Zener Diode changes on the RLC-1 Board

The following describes the process in changing your COR and PL zener diodes on the RLC-1 board. This change is needed if the controller is not recognizing the COR/PL inputs correctly. The indication of this problem is if your controller indicates a valid COR if a radio is not connected. This condition generally shows up when your COR is programmed as Active LOW. When the COR and/or PL is set for active high, and the controller does not recognize an active level (Open collector COR/PL input only) then the zener diode may be faulty. The *Plus* board option seems to have a more difficult time differentiating between high/low COR inputs. The zener diode change clears up this problem.

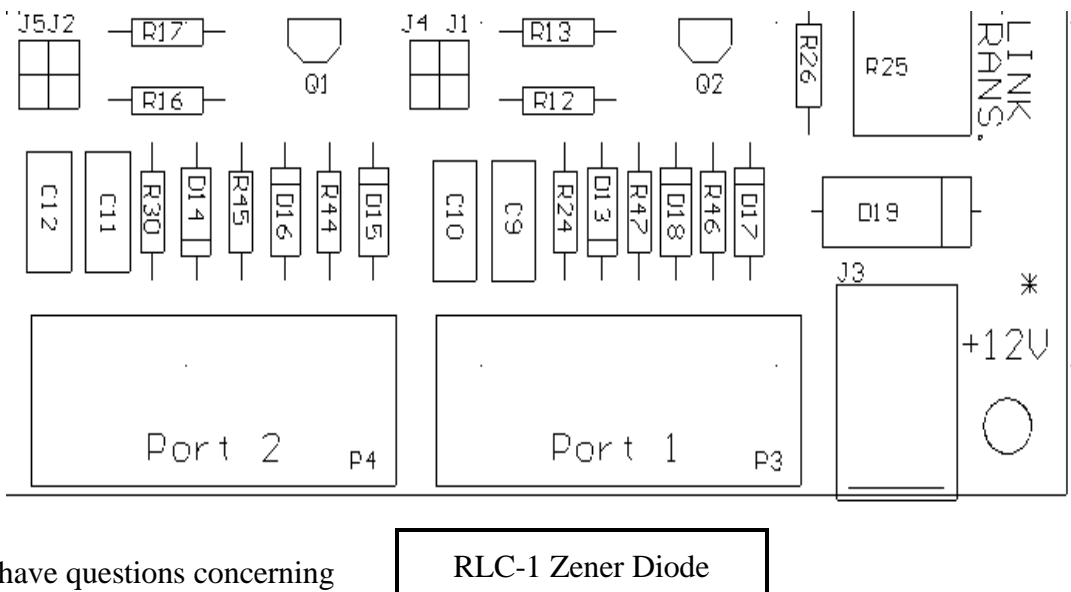
The cause of the problem is leaky zener diodes. The leakage current causes the pull-up resistor (+5 Volts) to be pulled down to a lower voltage. The problem occurs when the leakage current drags the voltage down to less than 3 volts. The replacement zener diodes (Motorola 1N751A) has minimal leakage current, so the steady state voltage is around 4.40 Volts. The zener clamping voltage maximum is 5.10 Volts. This voltage is within the safe operating range for the Motorola MC68HC711E9 uProcessor.

2) Locate zener diodes D15, D16, D17, D18. If you are concerned about removing the diodes from the PC board, simply clip the diodes from the top of the board. Then solder the new diodes to the top of the board where the old diodes were located.

Remember to pay attention to the diodes polarity. The cathode (Side with the bar) should be directed away from the DB-09 connectors. If you have questions concerning this modification, contact Link Communications, Inc.
